# ICC A117.1 Comments on 2nd Draft

## Proposal list to the 2017 A117.1 for the 2023 edition – 03-30-2025

### Proposal list to the 2017 A117.1 for the 2023 edition – 2<sup>nd</sup> draft comments

**FIGURE 307.4**  
**REDUCED VERTICAL CLEARANCE**

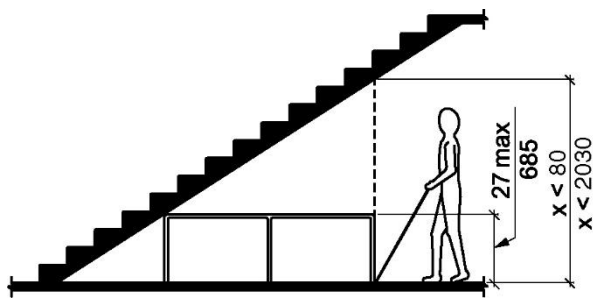
The code user would go to Section 307.4, Vertical Clearance, to figure out what they may want for a minimum door height. *We recognize this section is now called Headroom Clearance.*

Presuming Figure 307.4 is remaining the same but for renaming it headroom clearance, that

illustration and the exception allows doors closers/stops to be 78” above the floor. The current proposed modification may get interpreted by some inspectors that doors must also be 80” in height to make rooms for the door closers/stops when attached to them, but A117.1 does not specifically say a door must be a minimum height of 80 inches. The proposed changes in comment E-01-2023-AM simply makes it more difficult to read and understand what is being required. We believe the current A117.1 language is clearer and recommend reverting back to it.

**REASON:** This includes two changes. The first is a minimum height for a horizontal element. A height of 10 inches was proposed based on several factors. It should be high enough that it cannot be mistaken for a step on a stair. It should be high enough that it can be relatively seen by seeing people and not confused with the floor surface. And, it should be of a height that acts as a barrier to dogs. Which is also the reason for the second proposal.

**307.4 Vertical clearance.** Vertical clearance shall be 80 inches (2030 mm) minimum. Rails or other barriers shall be provided where the vertical clearance is less than 80 inches (2030 mm). The leading edge of such rails or other barriers ~~barrier~~ shall detectable ~~located between 10 inches (255 mm) and~~ 27 inches (685 mm) maximum above the floor. Low rails, curbs or platforms utilized as barriers that are located where they can be tripping hazard shall not be less than 10 inches (255 mm) minimum measured vertically above the floor surface.

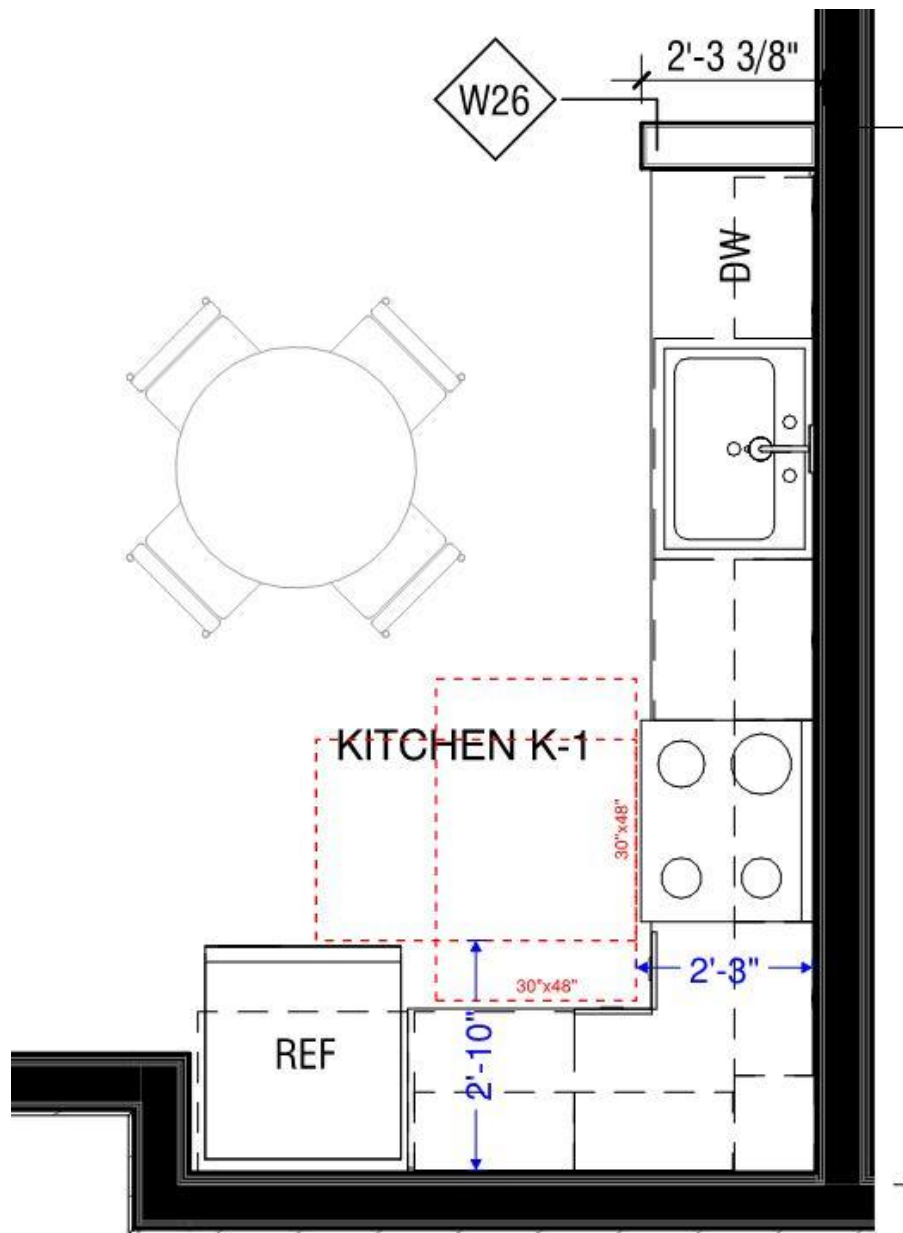
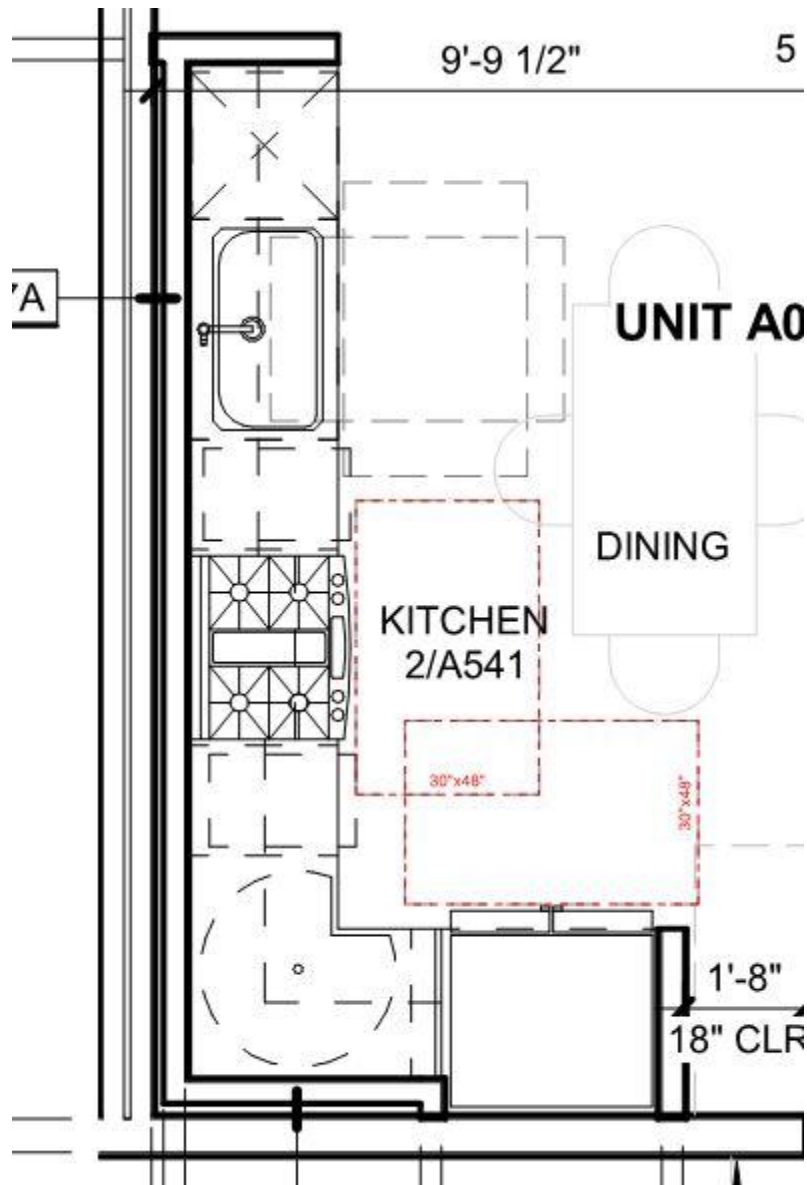
To a great extent, this proposal mirrors the Receptacles Task Group replacement proposal for Type A dwelling units, which was approved unanimously by the A117.1 Committee in the March 16, 2023, meeting. A full explanation of the changes can be found there. The additional changes and considerations which differ from that proposal are described here.

1. Receptacle outlets serving a dedicated use.
2. Where two or more receptacle outlets are provided in a kitchen above a length of countertop that is uninterrupted by a sink or appliance, one receptacle outlet shall not be required to comply with this section.

3. In a kitchen, where a clear floor space for a parallel approach cannot be located at a countertop in a corner between appliances, receptacle outlets over the counter-top shall not be required to comply with this section provided that the countertop area does not exceed 9 square feet (0.835 m<sup>2</sup>) maximum.

**FIGURE 505.10.1**  
**TOP AND BOTTOM HANDRAIL EXTENSION AT RAMPS**

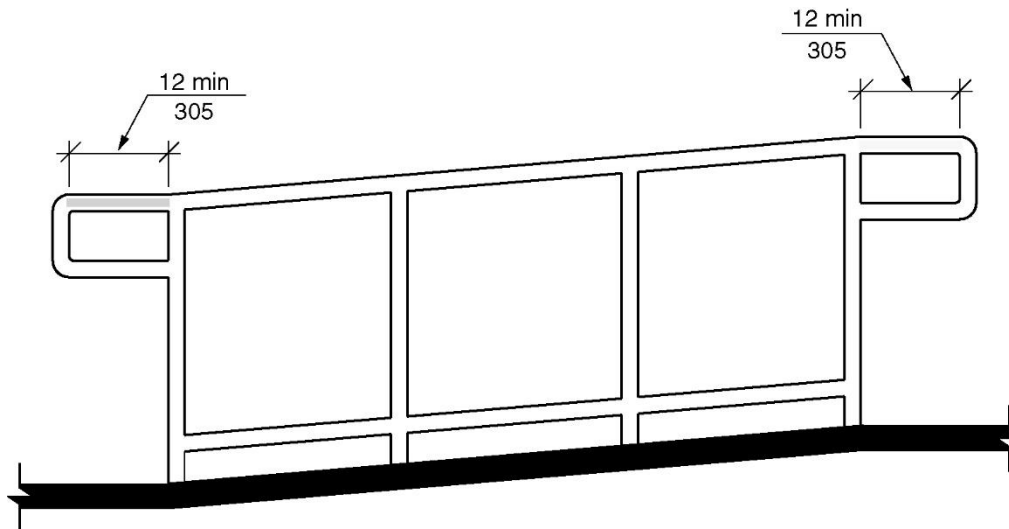
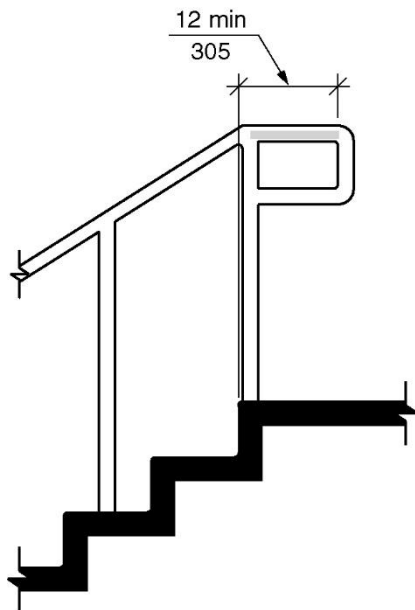
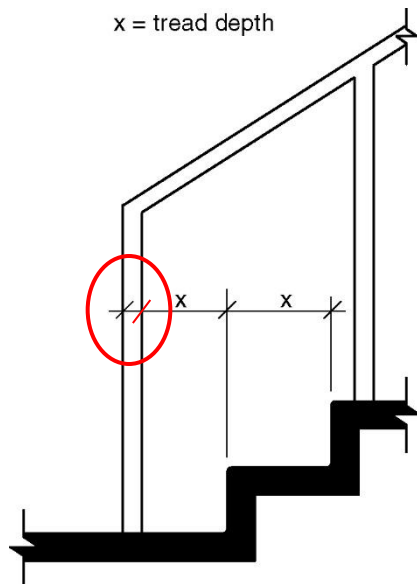
**REASON:** It is very common for stairs and ramps in juxtaposition to leave no room for typical handrail extensions but it is often feasible to make the handrail continuous at the intersection of the ramp and stair just as it is to provide continuity at adjoining ramp runs and adjoining flights of stairs.

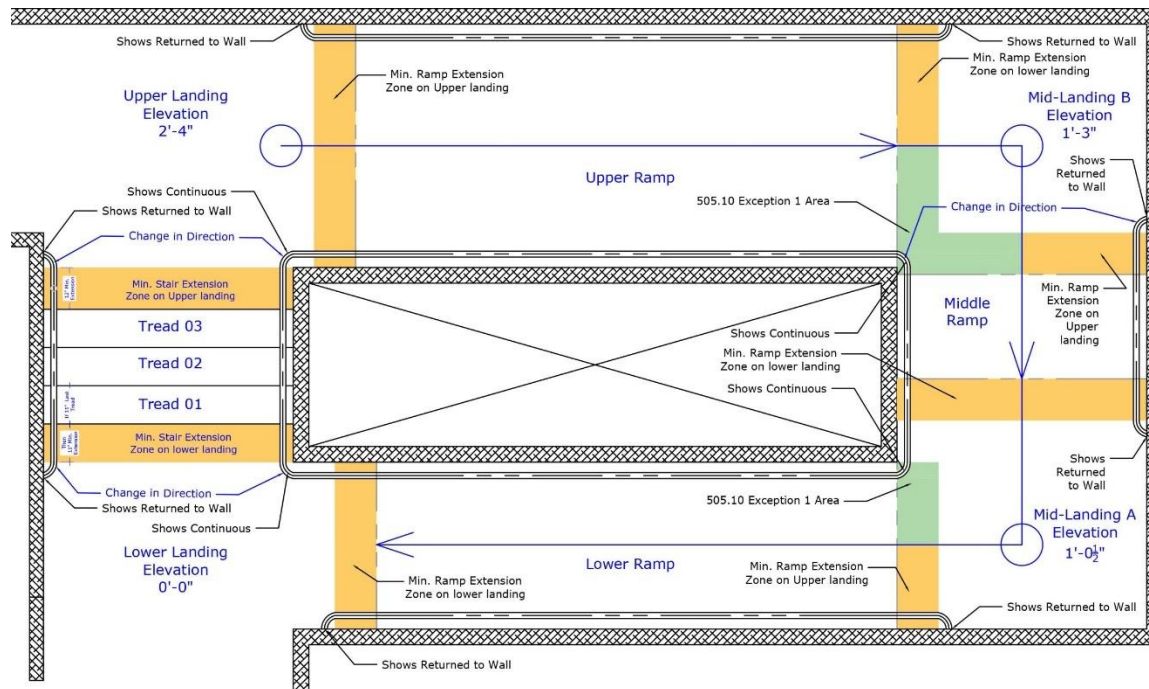
Let's first look at the last sentence in 505.10.1, which only allows a ramp handrail extension to connect and be continuous to another ramp, or it must return to a wall, guard, or landing surface. It defines no option to be continuous to another handrail of a stair flight, even after exceeding the minimum extension requirement. This however is done all the time in the field, and to date has not been called out or failed that I am aware of, except when the minimum extensions are not

completed before connecting the handrails. However the text is the text and should be discussed at a minimum for intent and technically when splitting hairs is allowed or not.

In the last sentence in 505.10.2, which only allows the handrail extension at the top of a stair flight to connect and be continuous to another stair flight handrail, or it must return to a wall, guard, or landing surface. It clearly defines no option to be continuous to a handrail of a ramp, even after exceeding the minimum extension requirements for both the ramp and stair.

In the last sentence in 505.10.3, which only allows the handrail extension at the bottom of a stair flight to connect and be continuous to another stair flight handrail, or it must return to a wall, guard, or landing surface. It again defines no option, as does 505.10.2, to be continuous to a handrail of a ramp.
